December 9, 2019

RE: 146 Robin Way

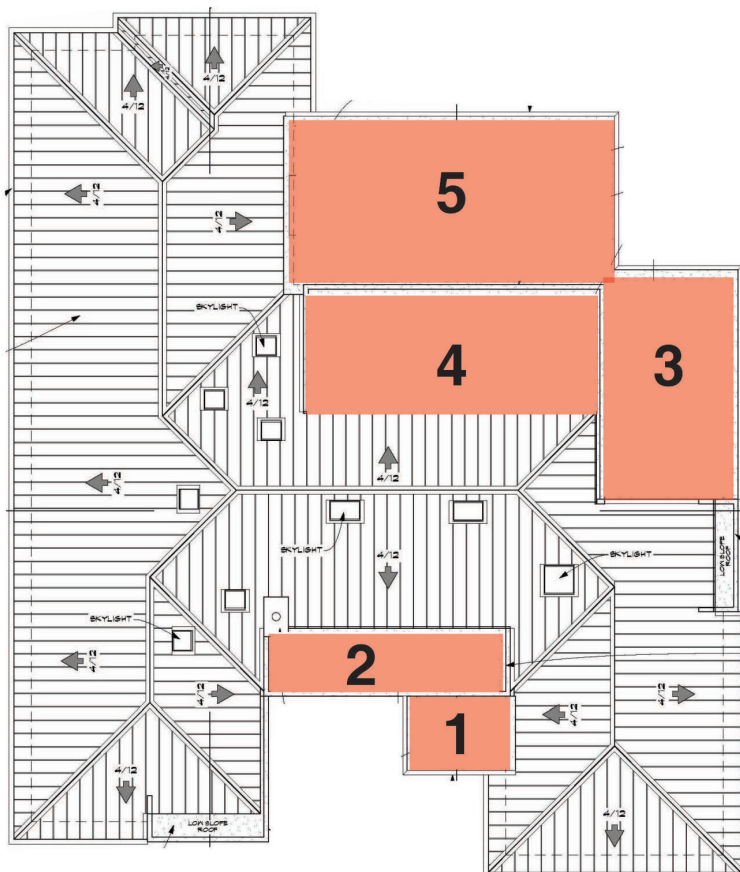
1. Multiple low slope roofs are not consistent with the Residential Design Guidelines.

3.5.1 Unify roof pitches

3.3.2 Height and bulk at front and side setbacks

- Avoid eave lines and roof ridge lines that are substantially taller than the adjacent houses.

3.3.1 Develop the house plans and elevations together

- Work within the traditional forms of the architectural style selected. Unless the architectural style selected clearly supports substantial complexity, generally keep building massing and roof forms simple as is the norm for traditional architecture.

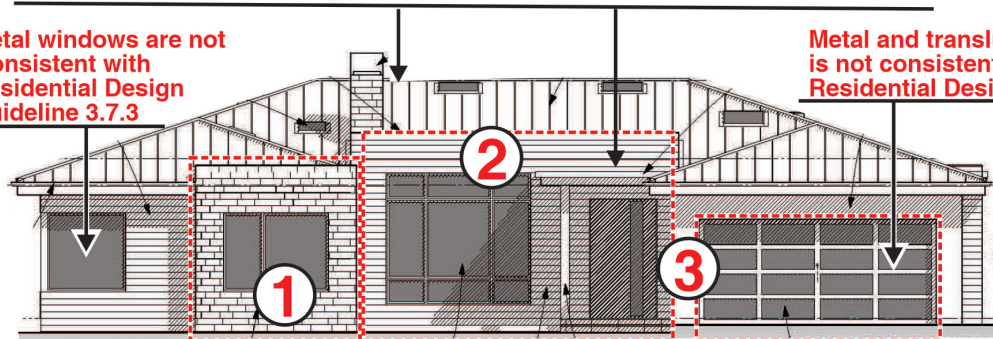
Multiple low slope roofs are not consistent with Residential Design Guideline 3.5.1 Unify roof pitches

- Metal roofing is not consistent with Residential Design Guideline 3.6.2 Design home entries with sensitivity to the architectural style**
- 3.6.3 Design home entries with sensitivity to the surrounding neighborhood**
- 3.8.2 Select materials that are sensitive to the surrounding neighborhood**

Metal windows are not consistent with Residential Design Guideline 3.7.3

Metal and translucent glazing is not consistent with Residential Design Guideline 3.4.1

Complexity of forms and materials is not consistent with Residential Design Guidelines and not consistent with the architectural style

- ① Stone
- ② Wood Siding
- ③ Stucco

Proposed garage door

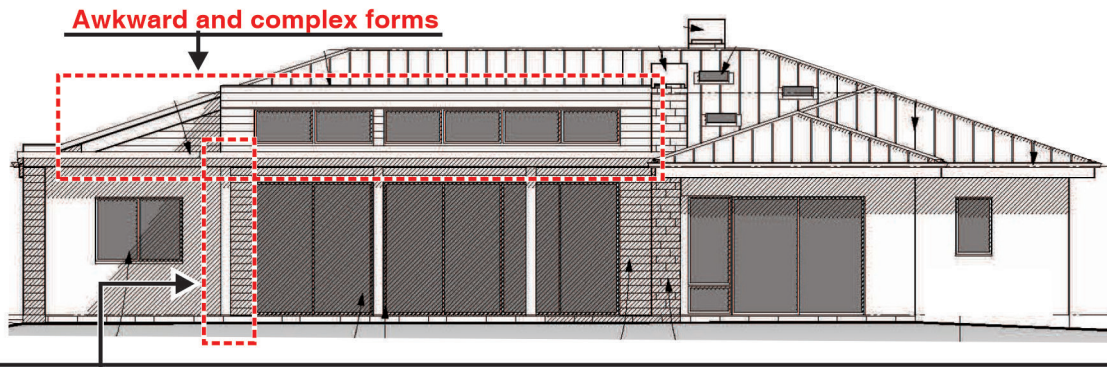
3. The garage door with metal and translucent glazing is out of character with this neighborhood, and is not consistent with Residential Design Guideline 3.4.1.

3.4.1 Limit the prominence of garages

- *Avoid designs that allow the garage to dominate the street facade.*
- *Integrate the garage into the house forms in a manner that de-emphasizes the garage doors.*

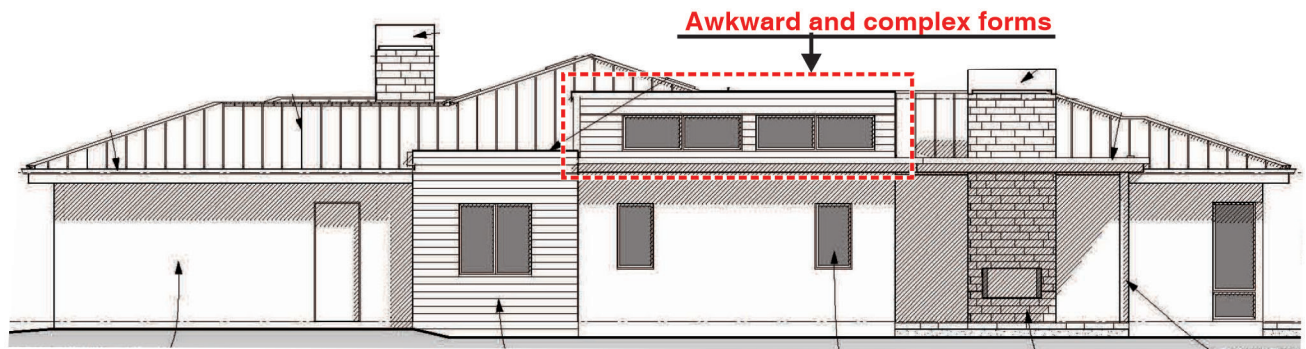
5. The low slope box forms at the rear of the house are very awkward.

Changing materials in the same plane is not consistent with the Residential Design Guidelines

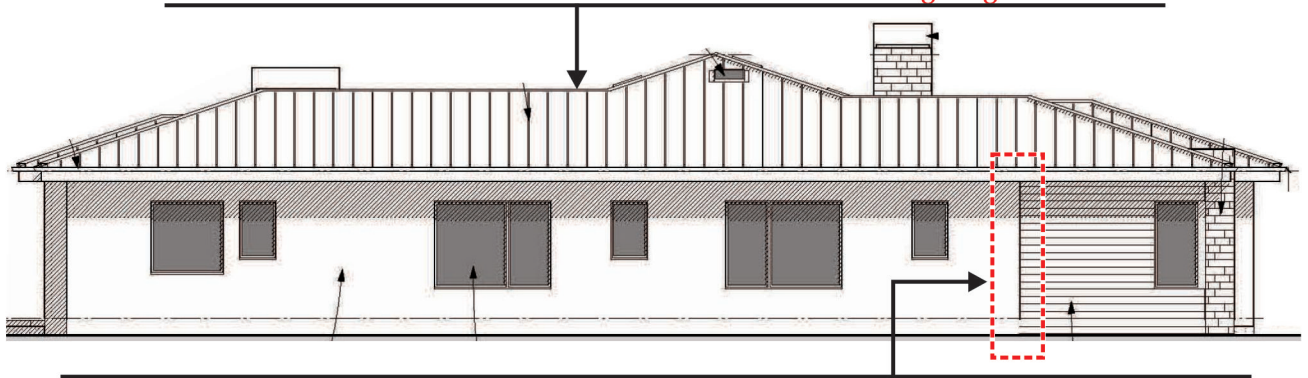
6. Changing materials in the same plane is not consistent with Residential Design Guideline 3.8.4.

Metal roofing is not consistent with Residential Design Guideline
3.6.2 Design home entries with sensitivity to the architectural style
3.6.3 Design home entries with sensitivity to the surrounding neighborhood
3.8.2 Select materials that are sensitive to the surrounding neighborhood

Changing materials in the same plane is not consistent with the Residential Design Guidelines
